APPLICATION No. **17/00968/MJR** APPLICATION DATE: 03/05/2017

LOCATION: LAND TO THE SOUTH OF SNOWDEN ROAD AND EAST OF WILSON ROAD, ELY, CARDIFF

PROPOSAL: 8 NO. NEW AFFORDABLE HOUSES ON LAND TO THE SOUTH OF SNOWDEN ROAD AND 12 NO. NEW AFFORDABLE APARTMENTS ON LAND TO THE EAST OF WILSON ROAD, ELY, CARDIFF

Drawing Title
SITE LAYOUT PLAN

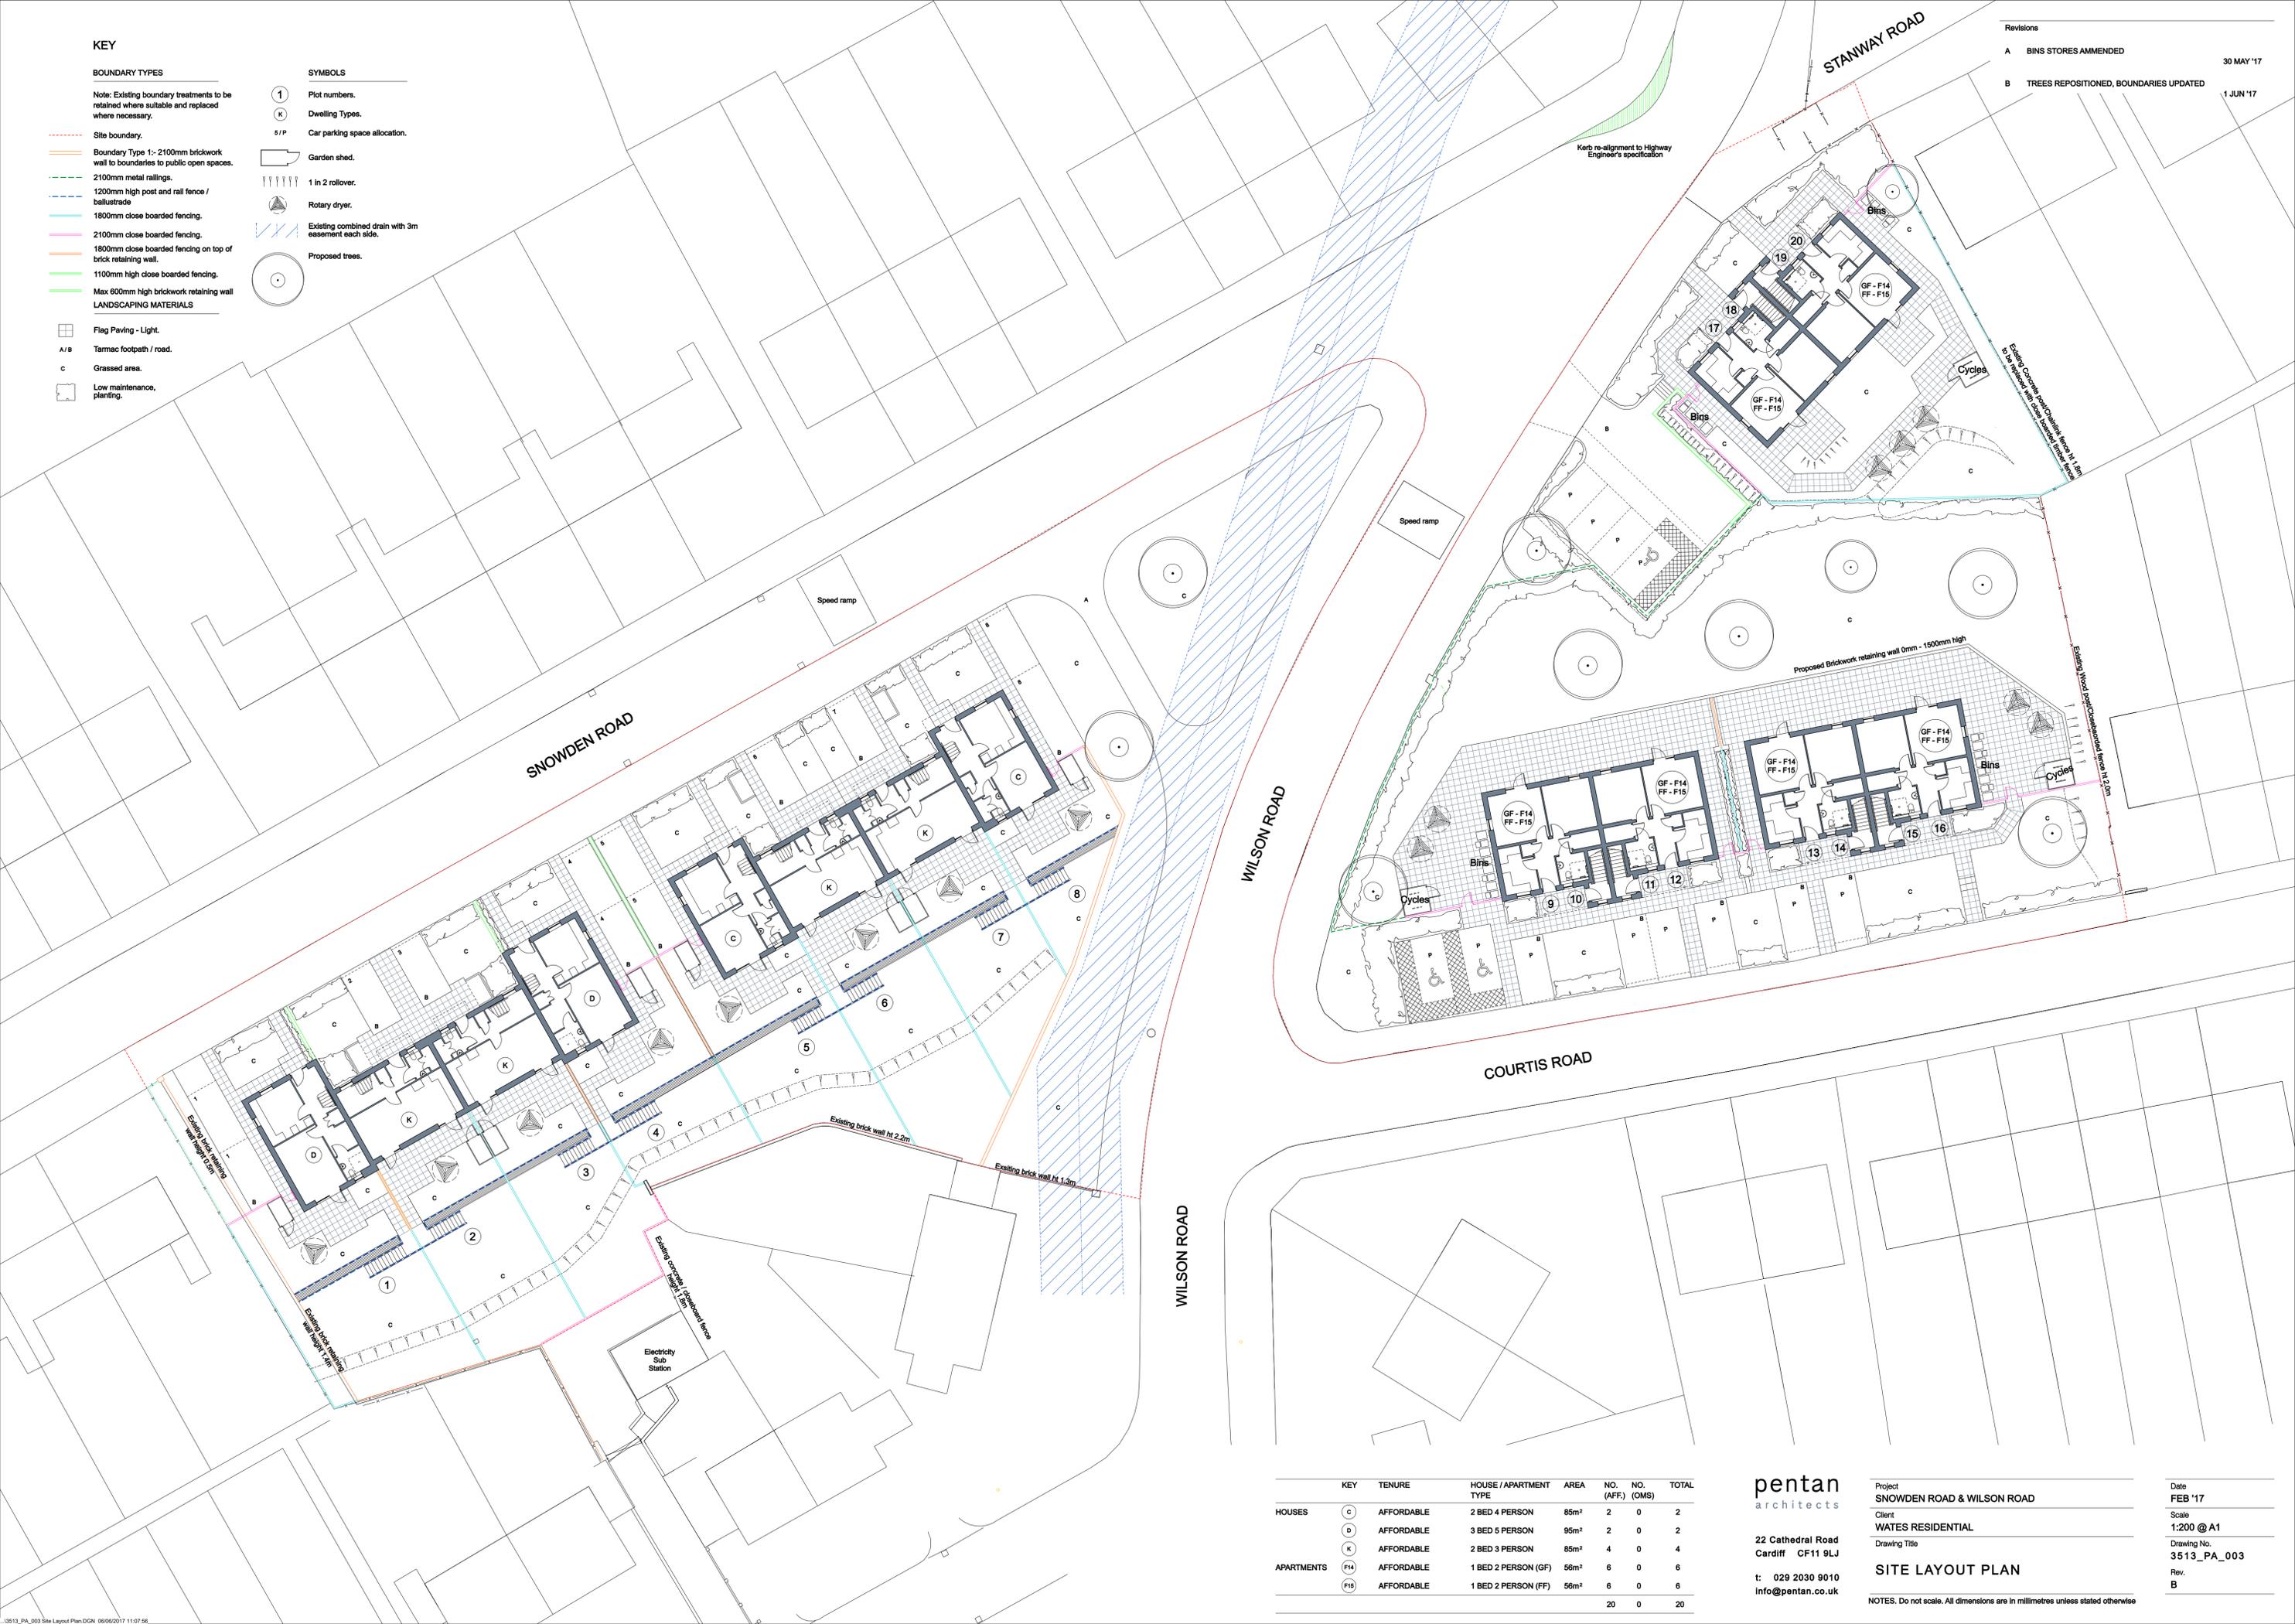
- There are 3 areas of grass 4a, 4b, 4c containing trees, so I need to confirm responsibility for maintenance of these.
- The fence shown between existing properties and the new flats is 1.8m mesh with concrete posts which although reasonably secure and allowing views through doesn't provide an attractive solution.

- 2.5. The information relating to the type and location of the root barriers is stated on the landscape proposal drawing.
 3. The updated site layout plan shows the boundary treatment to Wilson Road as a brick wall not a fence and the boundary to the west of plots 9 & 10 as a railing not a fence beyond the cycle store.

Regarding the comment concerning the 'mesh fence' we have indicated on the site layout drawing that this would be removed and replaced with a close boarded fence.
